URGENT MEDICAL DEVICE CORRECTION

Potential for Suspension of Dynamic Sensing Algorithm

Aurora EV-ICD™ (DVEA3E4) <UDI: 00763000368470>, Clinical EV-ICD (DVEX3E4) <UDI: 00763000217907>

October 2025

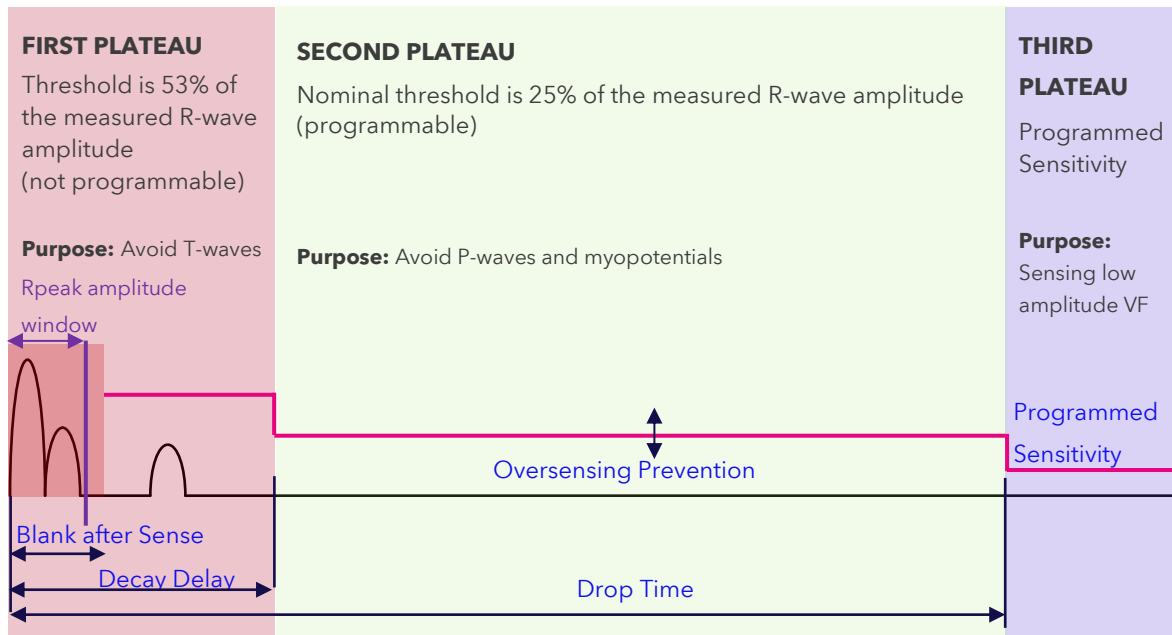
The dynamic sensing algorithm may become suspended at the first plateau if the following sequence of events occurs:

1. Charge-end occurs within 128.75ms of the prior sensed beat, thus interrupting the in-progress R-wave measurement-
suspension of the dynamic sensing algorithm occurs and the sensitivity plateau becomes static at 53%.
2. The sensitivity plateau will remain at 53% until a subsequent **R-wave amplitude exceeds this value.** In case of a significant drop in R-wave amplitude, delay in HV therapy delivery can occur.

Medtronic has implemented manufacturing changes, and devices manufactured with this update are not susceptible to this delay. In previously distributed devices, a device interrogation with the CareLink™ SmartSync™ Aurora EV-ICD™ application (D00U025) on CareLink SmartSync Device Managers will resolve the potential for this behavior (see Appendix B).
